ATTACHMENT A
PREDEVELOPMENT PLAN REVIEW COMMENTS TO APPLICANT

PREDEVELOPMENT PLAN REVIEW COMMENTS

Project Number: PPR2020-10001 **Date:** September 8, 2020

Project Description: Predevelopment Plan Review for the construction of a new 1-4 story multi-family residential project consisting of 58 units and one level of subterranean parking

RM-16-PK

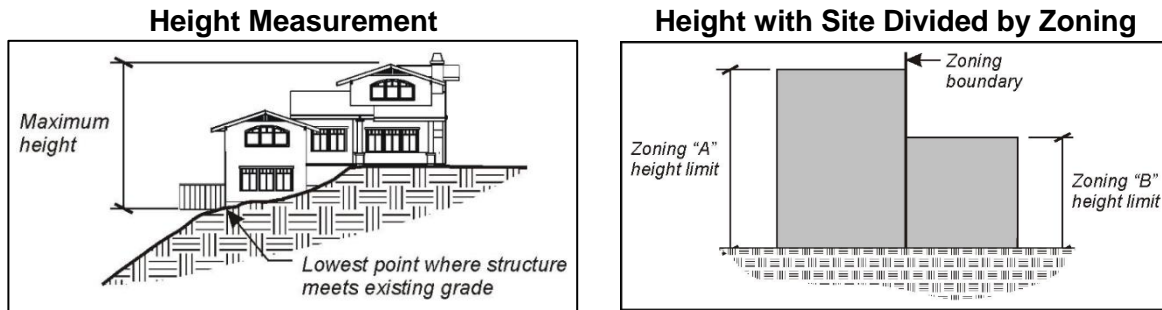
- c. **Front Setback (Parkwood Avenue).** The minimum front setback shall be the average of the front setbacks of the developed lots, but not less than 20 feet. In calculating the blockface average, measurement shall be from the front property line to the principal structure. Building projections (such as eaves or bay windows) and unenclosed porches shall not be used as the reference point for this measurement. Be advised, not more than 30 percent of the front setback shall be paved within a residential zoning district.
- d. **Side Setback (south).** 5 feet to within 20 feet of the rear property line; none required in the rear 20 feet.
- e. **Rear Setback (east).** None required.

Plans do not reference setbacks or property lines above the ground floor. However, at the ground floor, setbacks proposed within the CG zone along street frontages (front and corner) range between zero feet and 14 feet. Along the south side property line a 5'2" setback is proposed at the ground floor. Within the RM-16-PK zone, the ground floor plan references a 10-foot side setback (south). There is no setback dimension to the closet point of the structure on the east and west. In addition, there is not enough information to determine whether the portion within the RM-16-PK zone complies with the front setback requirement. There are approximately 15 developed lots on the block in the same zoning district (including subject). Plans shall reference lot lines, easements, dedications and setbacks at each level. The plan shall also include a front setback calculation and exhibit to verify compliance with the requirement.
